Wiltshire Council Planning Consultation Response

Application No: PL/2025/08144 PP and /08364
Alterations to interior of existing building, adaptation & extension of existing side extension, relaying of forecourt, general repairs & upgrades to fabric, provision of PV array to rear roof slopes & change of use to suit new leisure facility & cafe.
Dewey House, North Row, Warminster, BA12 9AD

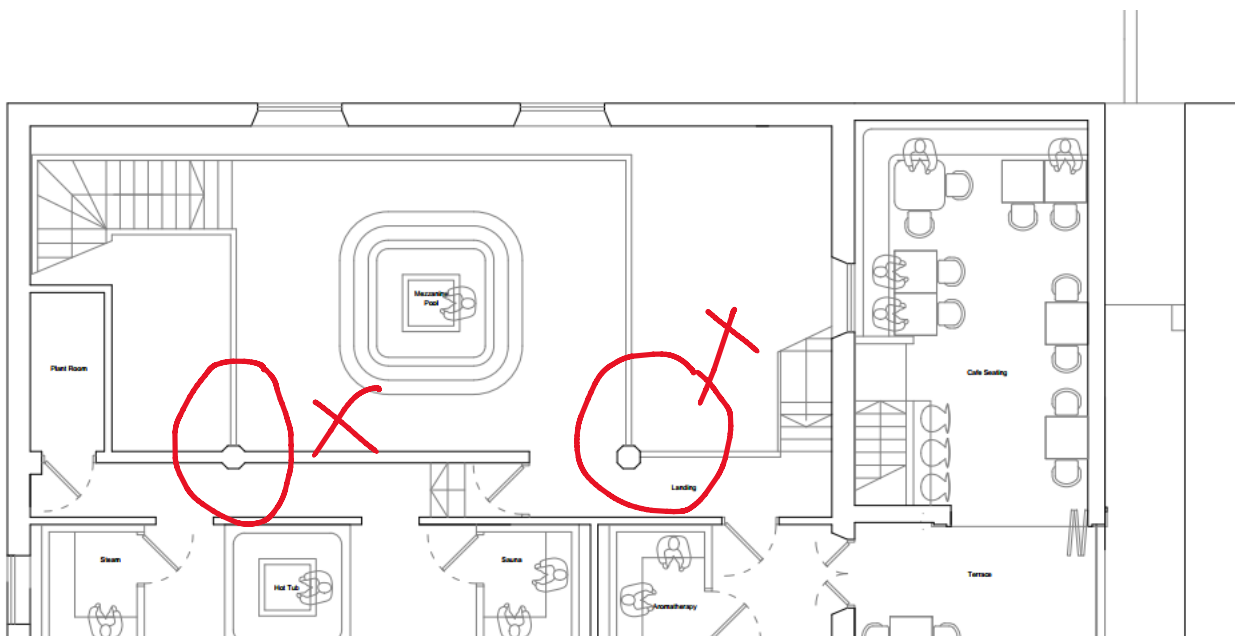
What is the impact on the side elevation (historic fabric)?

The current (altered) first floor door would remain to access the 'terrace'. The first floor window (rear side) would be concealed by the two-storey element – but it appears in the floorplans so retained and internalised presumably. Brickwork, stringcourse and stone quoins covered up by extension. At ground floor – blocking of rear side doorway and internalising a window.

A two-storey linked extension is problematic because of the scale and impact but perhaps not impossible. I would strongly recommend that the extension is linked to the existing dwelling in a largely glazed way so that there is a clear visual separation between the host building and the extension. The new extension needs to be a 'wow' moment. I suggest also that the extension is set slightly further back than is shown.

In terms of the current proposals, I would avoid brick – given the existing building is brick. Much more information on the handling of abutment of the new and old is required, (ie there is a large downpipe in the middle of the wall – would this remain?) including section details. The existing side wall should remain unplastered (also there are remnants of render – what would happen here? Consolidation/repair or removal and if so, how?).

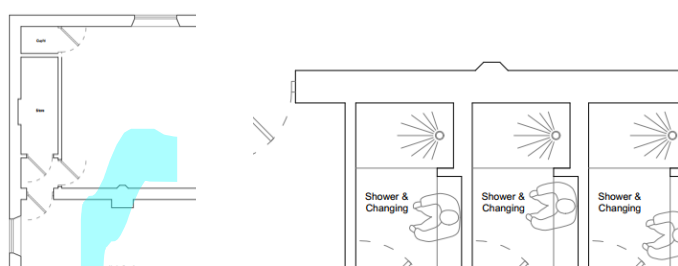
At ground floor in the earlier part of the building – three separate WCs are installed (where are the services coming from?), the second meeting room is divided up into 3 changing rooms and a treatment room.

What is that bit of masonry on the north wall which is proposed for removal? Presumably, if tall ceilings, the units like the changing rooms don't need to be full height (following the site visit, I understand that details such as this have yet to be worked out). One positive is removal of a partition that cuts across a window.

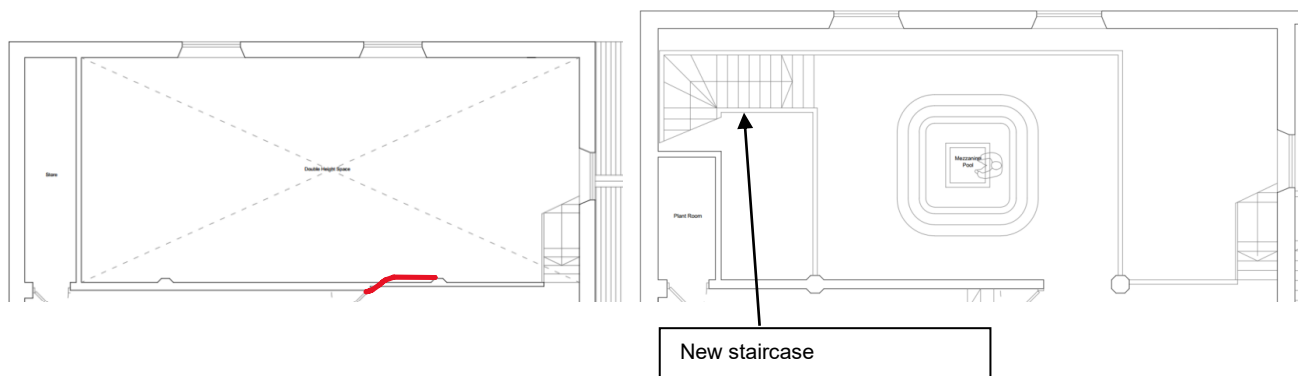
Proposed first floor – new staircase – no objection subject to acceptable details (see previous comments).

At the front of the building (the older core), there are two rooms – a corridor is formed: a cold plunge pool, a series of showers, steam rooms, saunas etc.

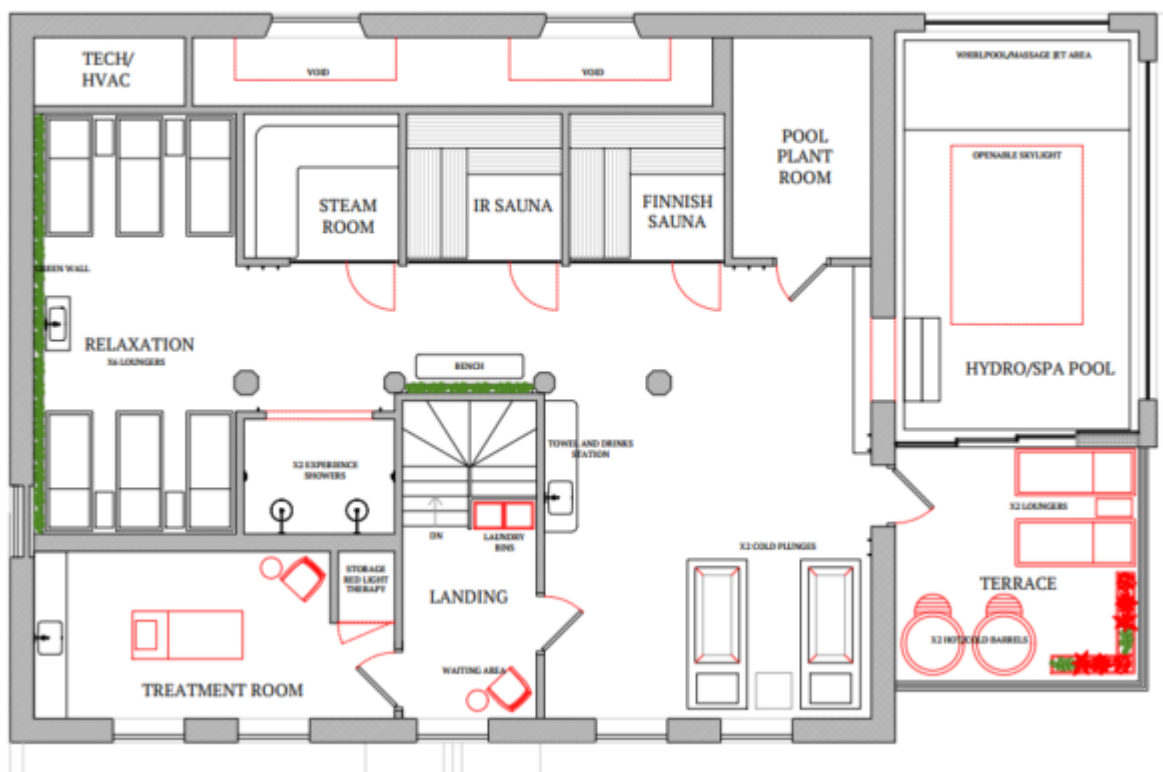
In respect of the current iteration, the architect has taken on board my comments about a glazed link to provide a degree of separation. At first floor we have a series of glazed panels which now enclose the first floor terrace.

On a point I made previously, I would still like to see a greater degree of set back in respect of the extension.

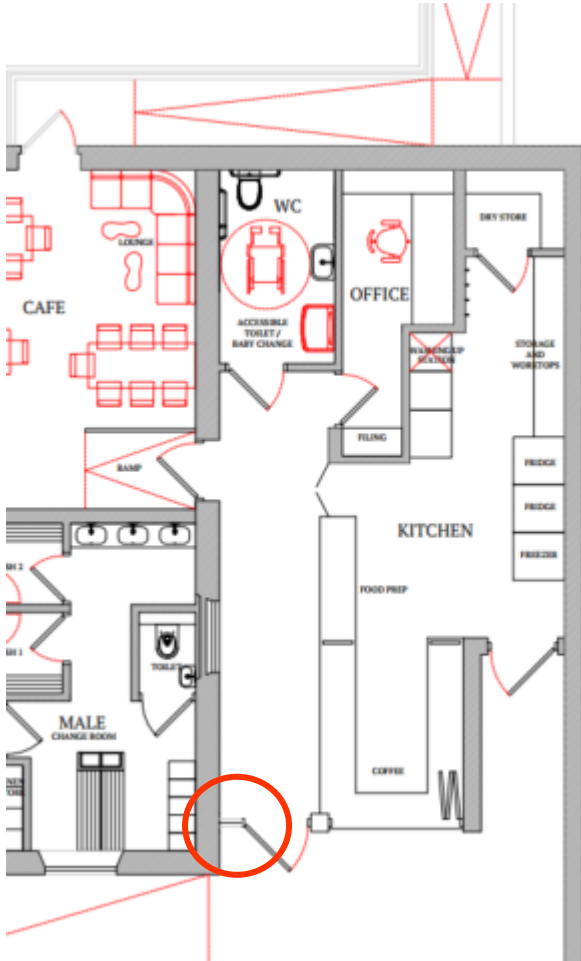
Also I note that the proposed floor plan suggests it is not a glazed 'link' but actually really just a different treatment for this part of the elevation. This was not what I had envisaged and I don't think that is what is implied by the proposed coloured elevations which shows a shadow line, implying that the glazed link is recessed/set back from the extension. As such, the drawings are misleading.

In respect of the proposed materials, there was a discussion over the use of Corten and also glazing. The rendered image suggests a slightly translucent (sand-blasted), or perhaps it is just the way glazing is drawn but no clarification is provided under section 4 of the D&A statement (appearance and materials). I would recommend that this is clarified with a separate materials schedule.
